Inland Empire Energy Center

(01-AFC-17)

Amendment No. 1

(GE H Technology and Additional Laydown Area)

Figure 2-1. General Arrangement

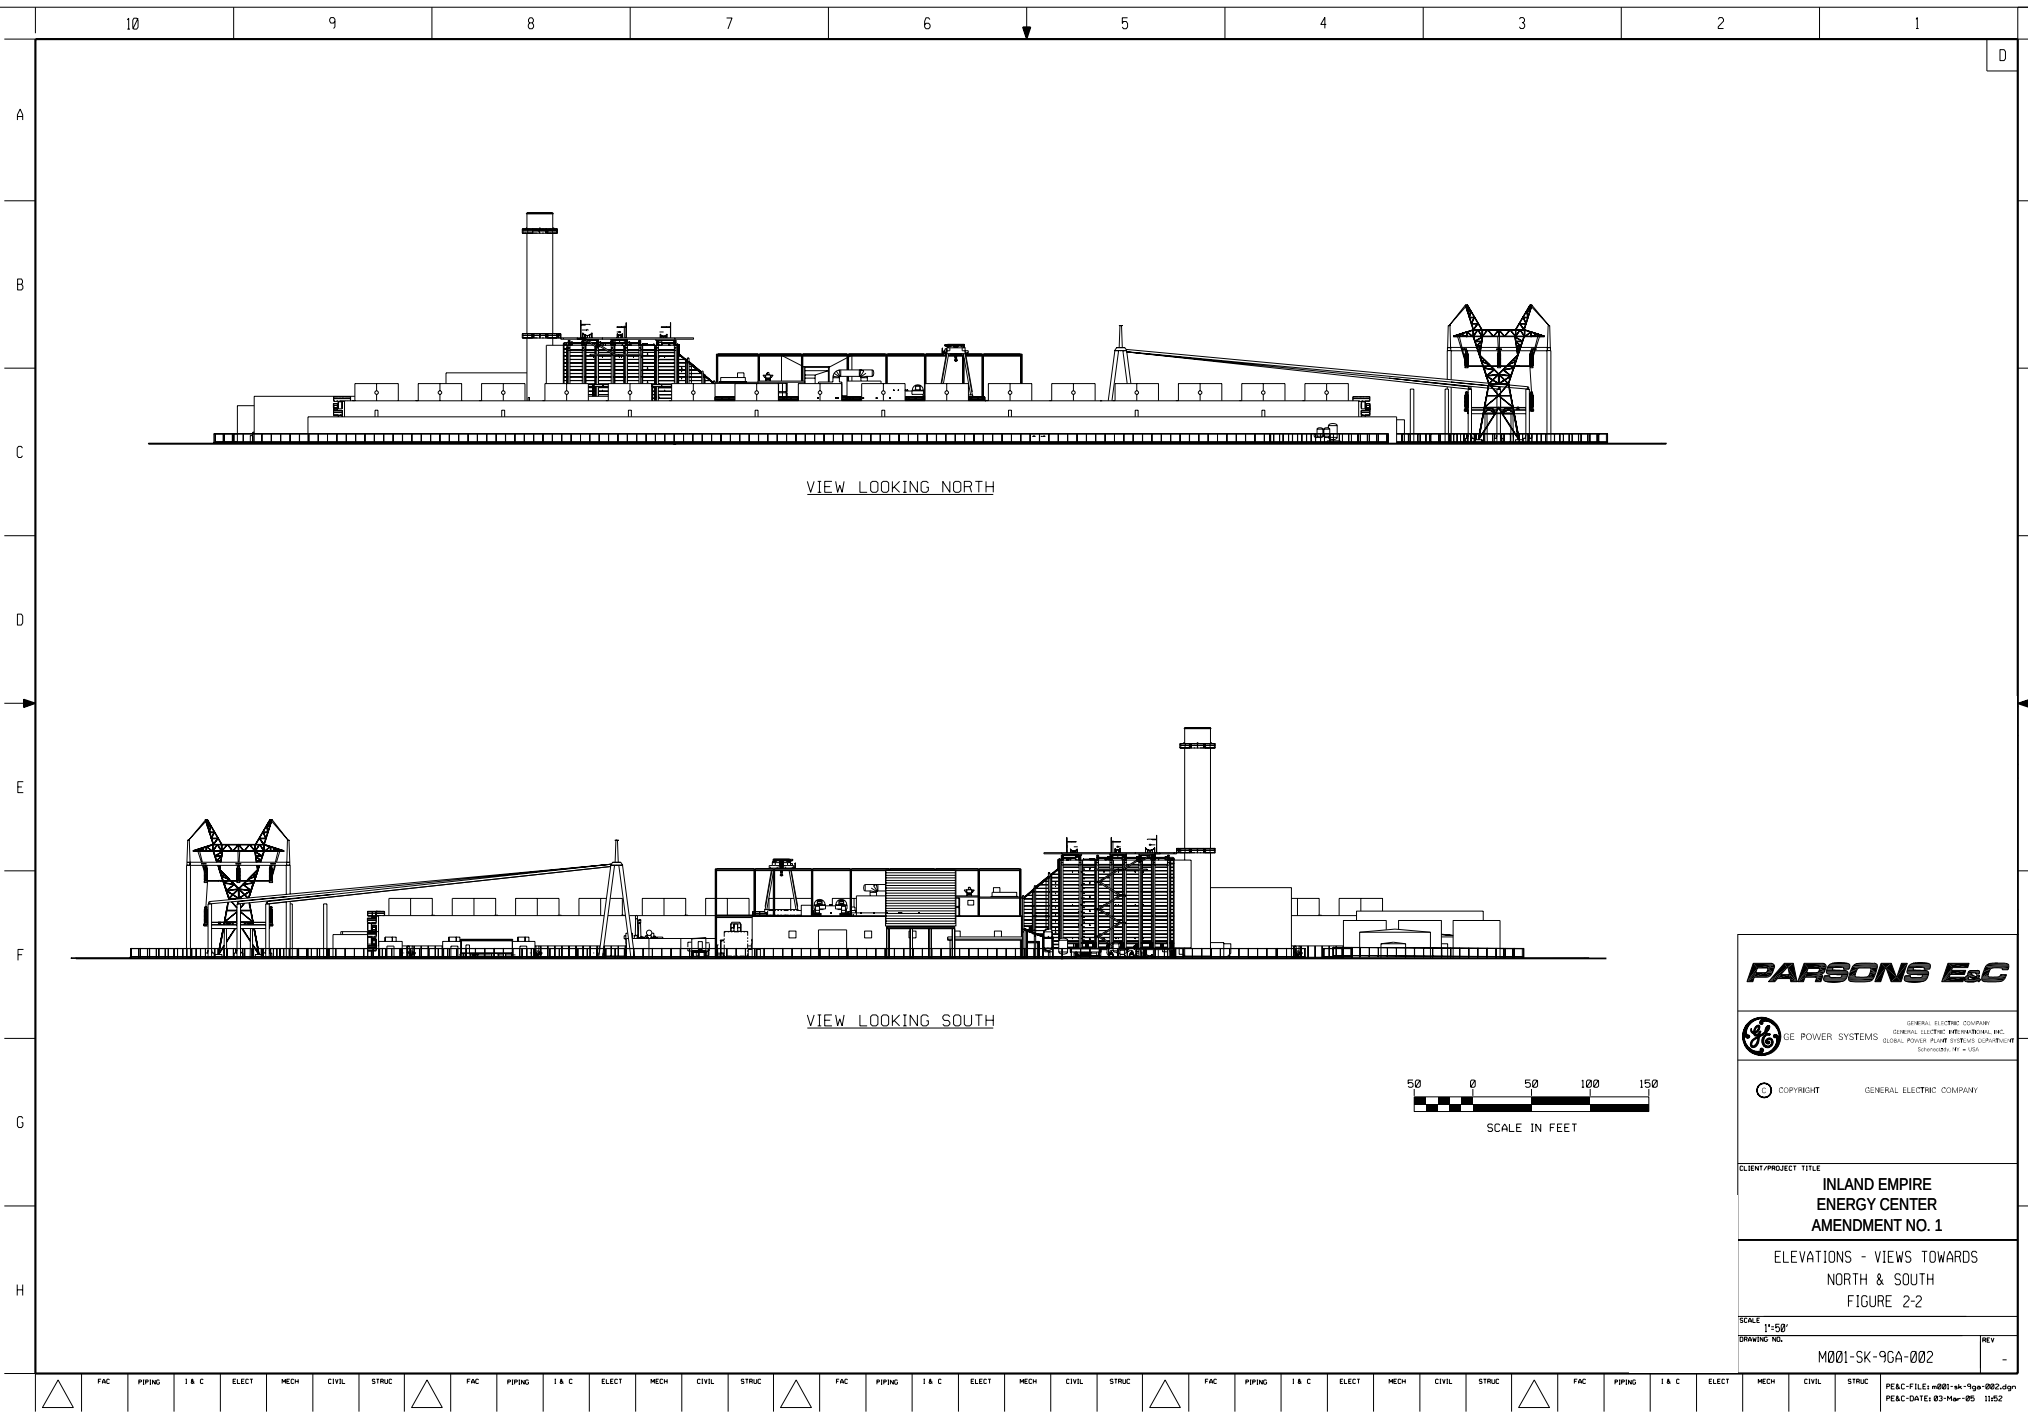
The proposed change in the power generation configuration will require a revised site arrangement as shown in Figure 2-1. Including access roads and landscaping, the energy center will still occupy approximately 35 acres of the 45.8-acre project site. The energy center fenced area has been increased from 24 acres to approximately 28 acres. Figures 2-2 and 2-3 show north, south, east, and west elevations. Key revisions to the site layout are as follows:

- ∞ Because the CTs and steam turbines STs share common shaft lines, the entire line-ups are pedestal mounted at the ST elevation with the condensers located directly below the STs. The CTs are thus higher in relation to ground level in the revised design.

- € The auxiliary boiler has been relocated to the area between the two HRSGs.
- € A chiller and space for a future thermal (chilled water) storage tank have been added and are located in the area between the two HRSGs. This system will provide chilled water for cooling of the CT inlet air, replacing the fogging systems used in the previous configuration.

- € Onsite gas compressors with fin-fan coolers have been added and are located in the area north of the east-cooling tower.
- € The natural gas metering area has been relocated to the south side of the east-cooling tower, thus allowing access by the gas company without the need to enter the energy center.

- € Areas for gas conditioning equipment have been added on the north side of the HRSGs. These areas will include equipment to moisturize and filter the fuel gas prior to use in the CTs.

- € Condensate storage tanks have been added and are located north of the STs.
- € A second standby generator has been added such that each CT/ST/HRSG train now has a dedicated standby generator. The standby generators are located south of the respective HRSG stacks.

ELEVATIONS - VIEWS TOWARDS
 NORTH & SOUTH
 FIGURE 2-2

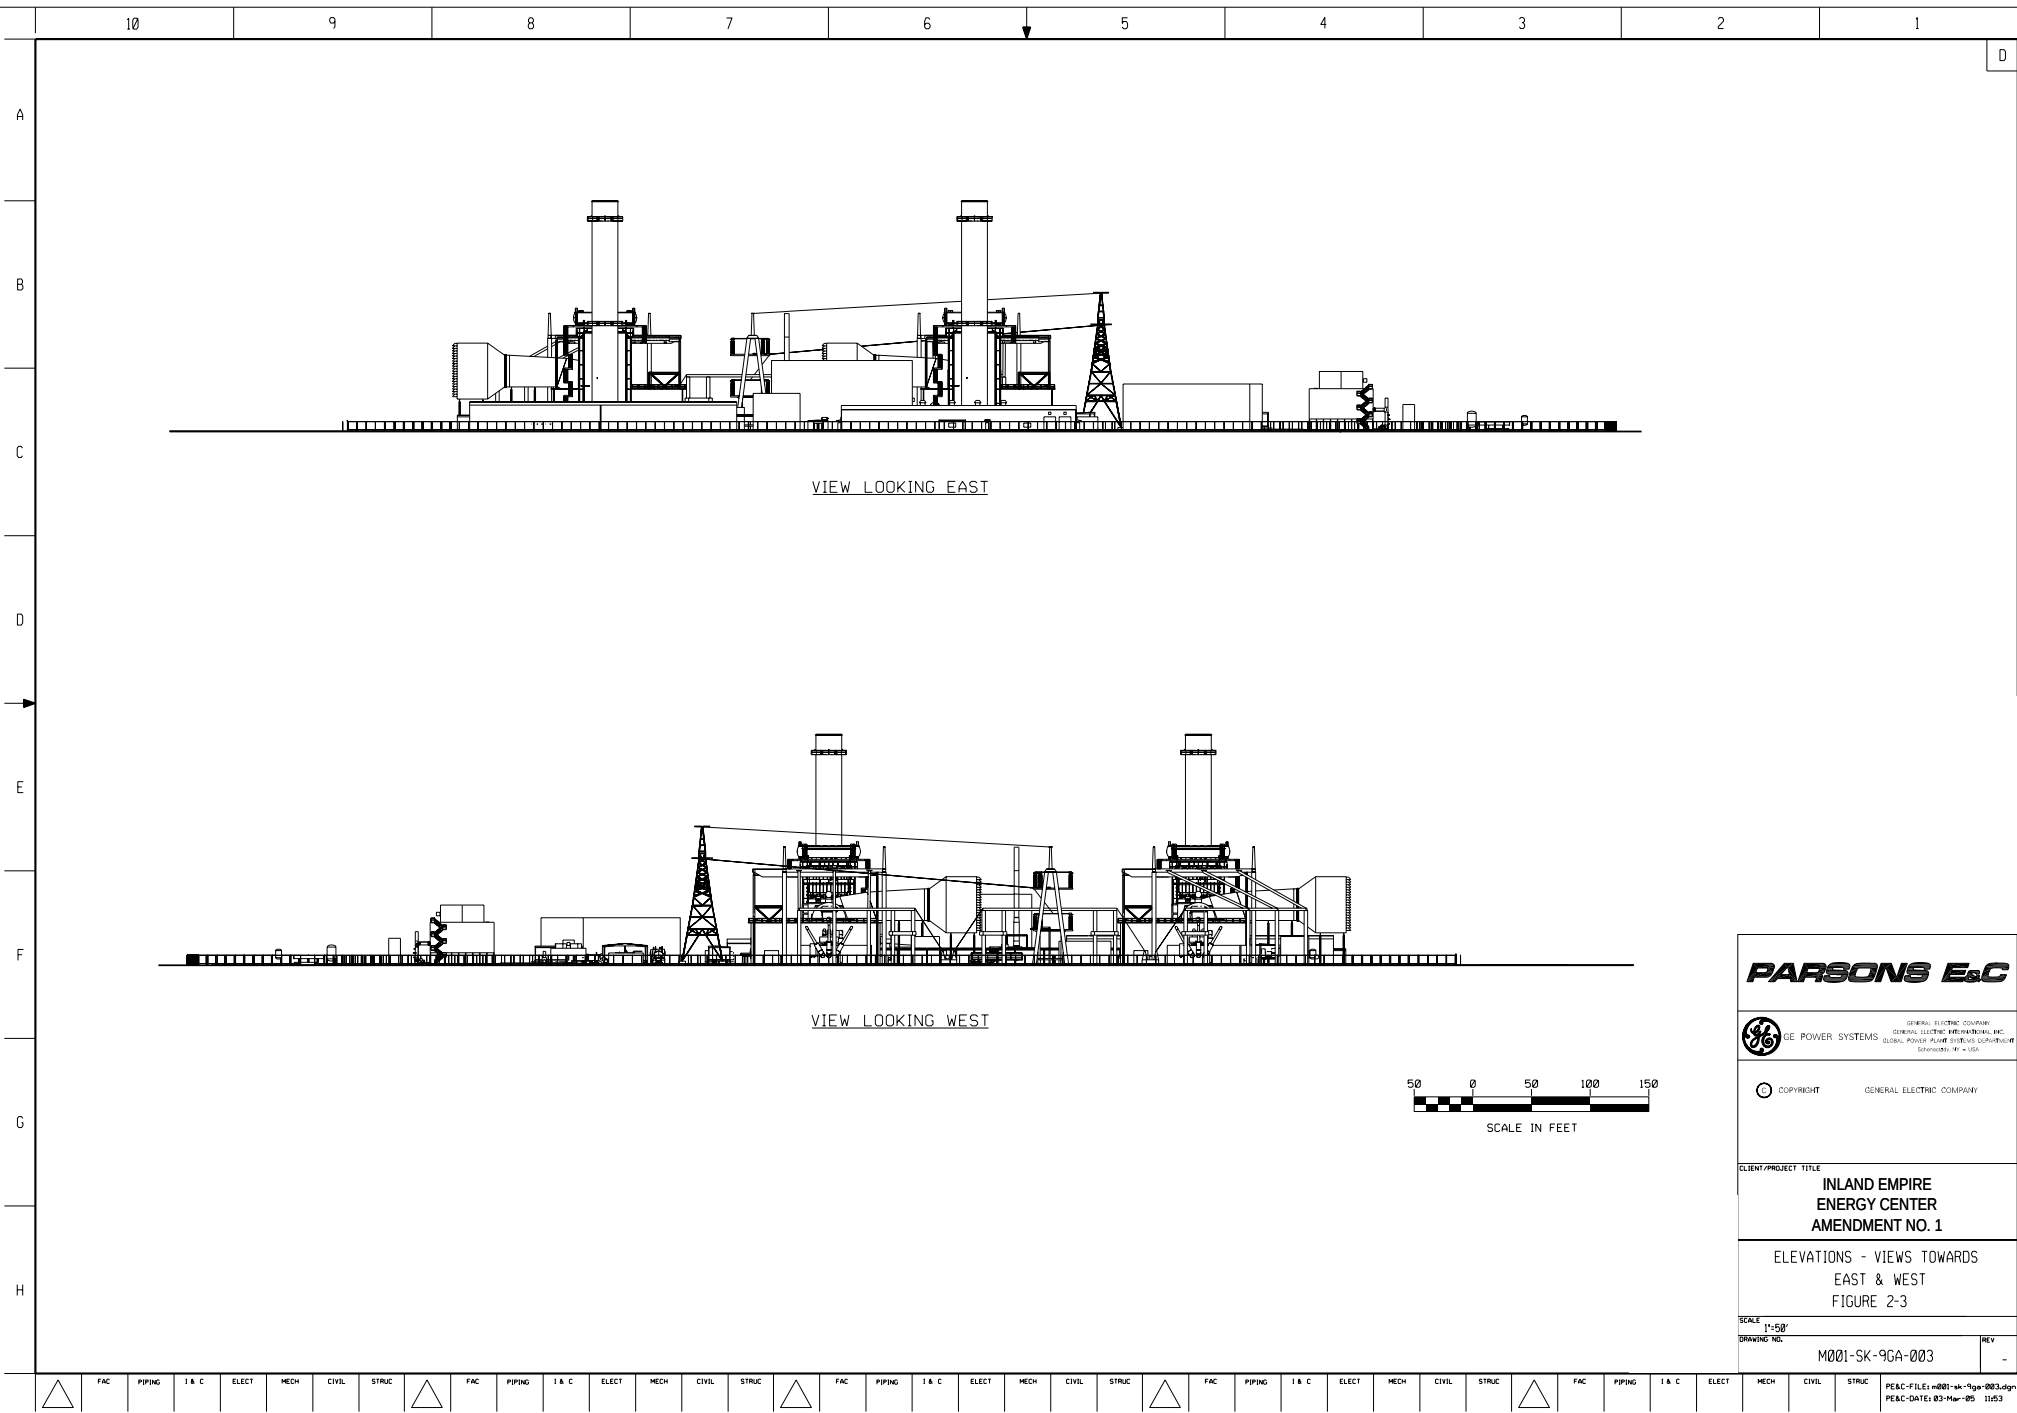
The revised site arrangement is presented on Figure 2-1 in Section 2.0, and Figures 2-2 and 2-3 present elevation views of the current design. Table 3.12-1 compares the dimensions of the project features under the previously proposed design with those of the amended design. Figure 3.12-1 is a land scaping plan that shows the currently proposed site arrangement in the context of the landscape plan mandated by Condition of Certification VIS-3³.

**INLAND EMPIRE ENERGY CENTER
 AMENDMENT NO. 1**

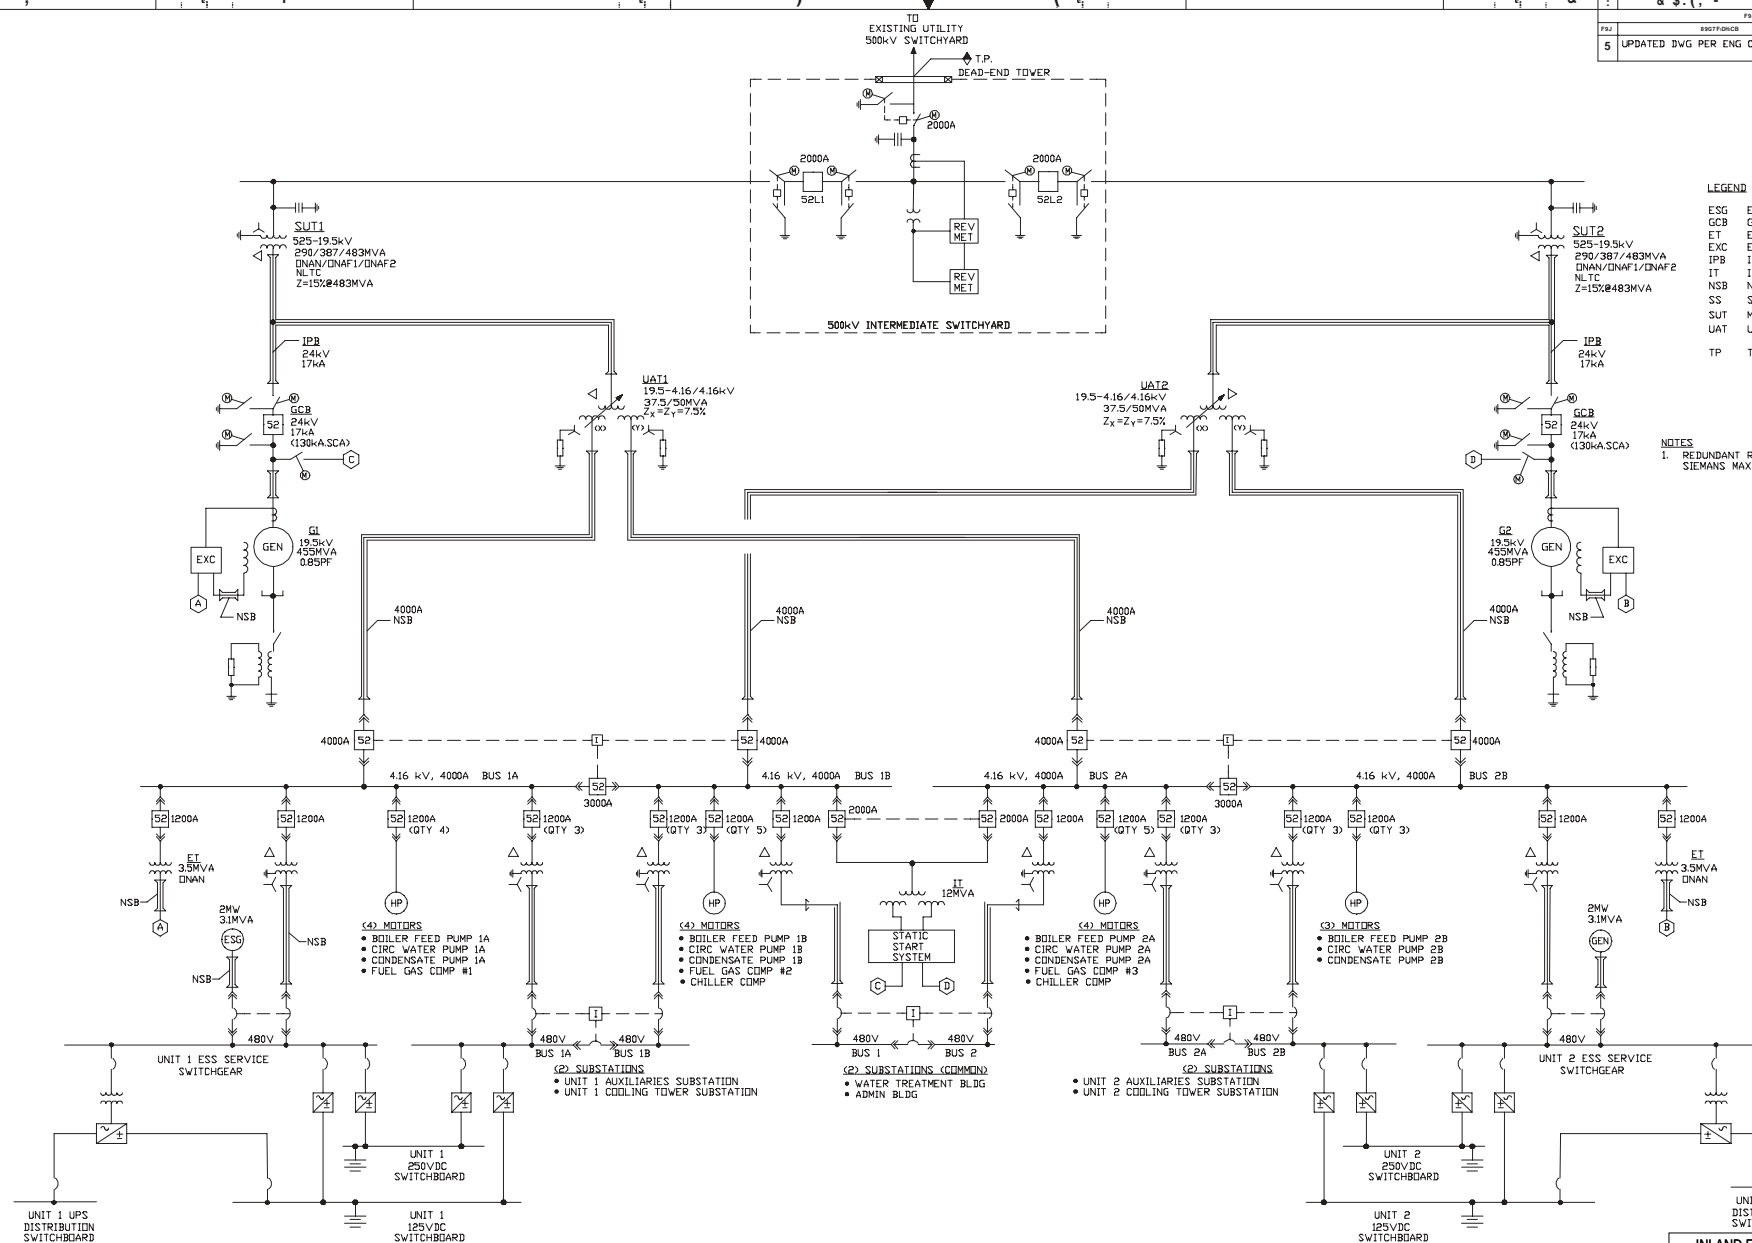
An updated single-line diagram of the facility's electrical system is presented in Figure 2-5. Power will be generated by the two GE S107H Systems at 19.5 kV and then stepped up to 500 kV for transmission to the grid. With two generators instead of three, the IEEC switchyard has been changed to a two-breaker radial feed configuration instead of the four-breaker ring bus configuration of the previous design.

A 2,000 kW diesel-fired standby generator will be connected to the essential services bus of each GE S107H System. These units will provide power to essential loads when power is not otherwise available through the 500 kV grid connection.

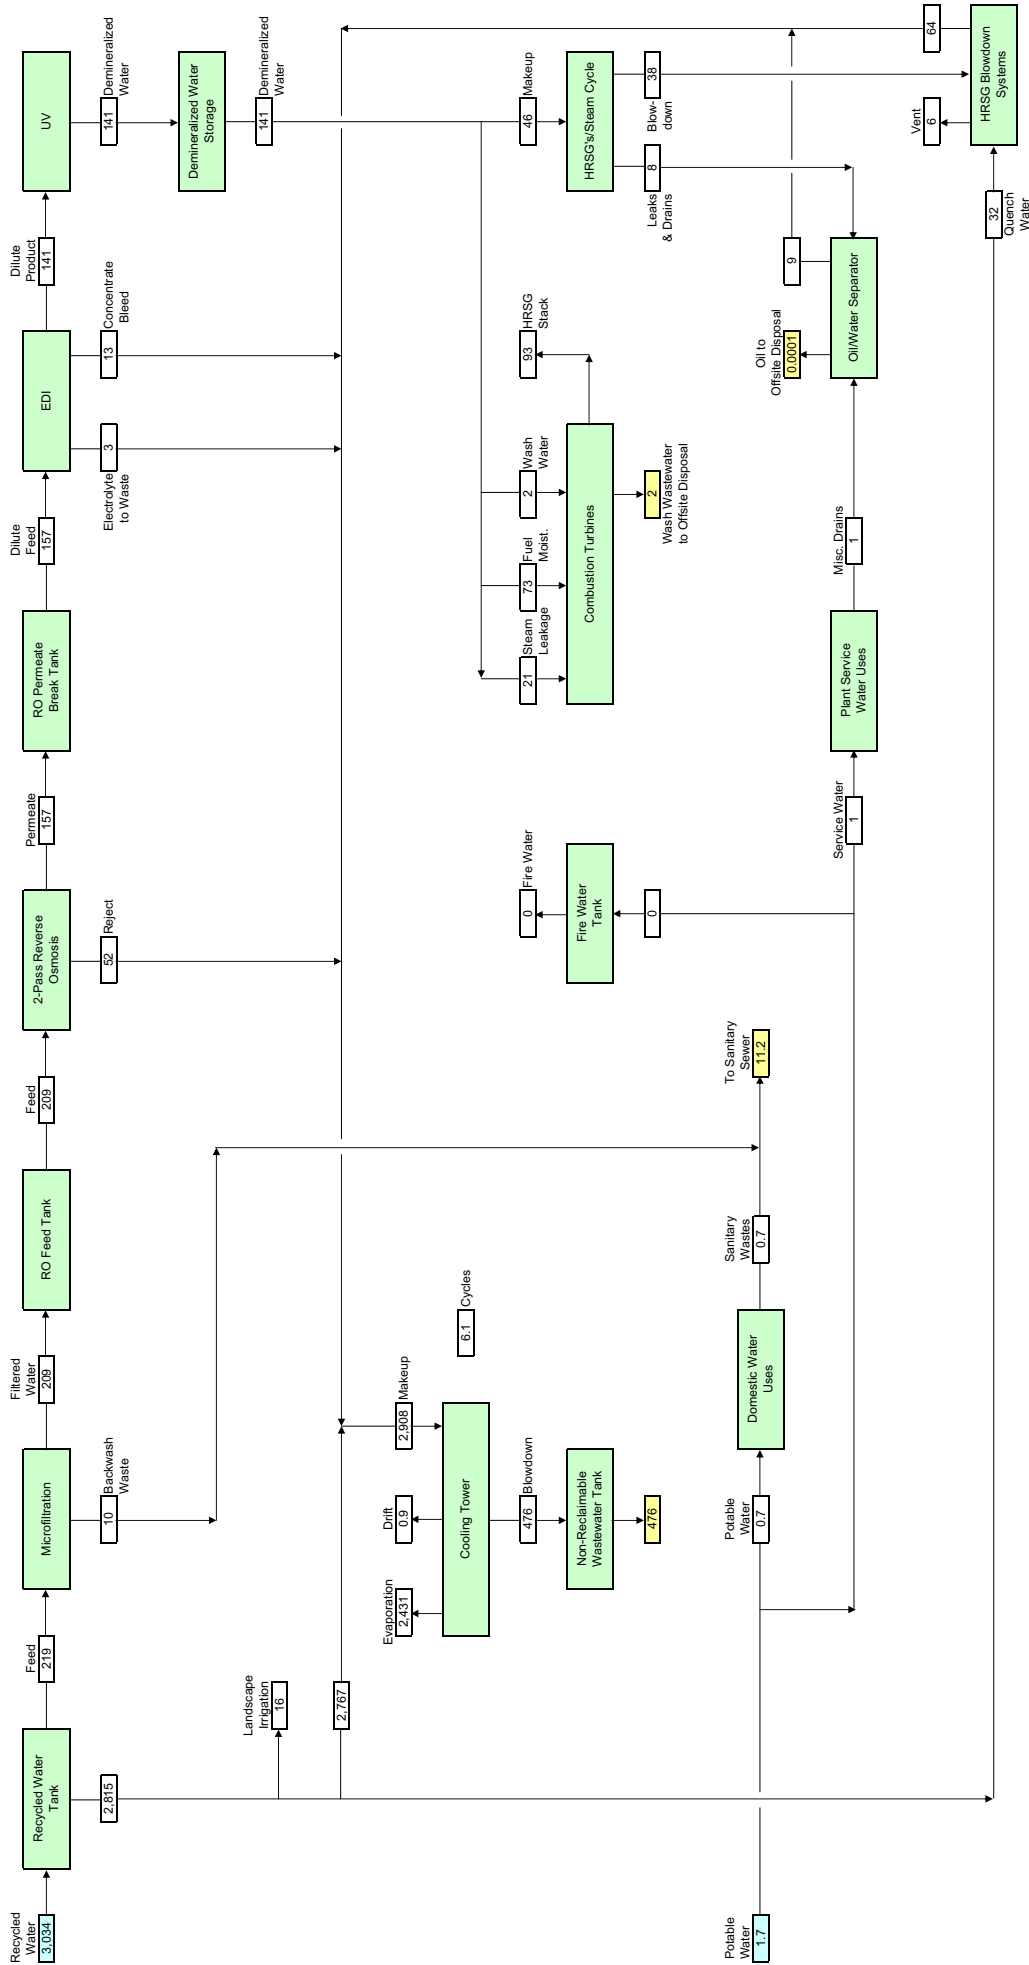
- ✱ Figure 2-6 – Operation at 63 degrees F with two CT/STs operating at 100% load with CT inlet air chilling
- ✱ Figure 2-7 – Operation at 98 degrees F with two CT/STs operating at 100% load with CT inlet air chilling

- € Onsite electro-deionization (EDI) units have replaced the offsite-regenerated mixed-bed units as the polishing step in the production of demineralized water.
- € An ultraviolet (UV) disinfection process has been added downstream of the EDI units.
- € CT steam injection for power augmentation has been eliminated.
- € CT inlet air fogging has been eliminated (replaced with inlet air chilling).
- € Fuel moisturization has been added (a new demineralized water demand).

- € The recycled water storage tank capacity has been reduced from 2.5 million gallons to 2.1 million gallons. This capacity remains sufficient for 8 hours of operational storage at the new maximum flow of 4,418 gpm.
- € The two demineralized water storage tanks have been increased in capacity from 150,000 gallons each, to 210,000 gallons each, to provide additional reserve capacity.
- € Two new condensate storage tanks have been added; one for each GE S107H System. Each tank will have a capacity of 50,000 gallons.
- € Space has been allocated for a potential future thermal storage tank. This tank has been sized to store up to 4.5 million gallons of chilled water for CT inlet cooling.
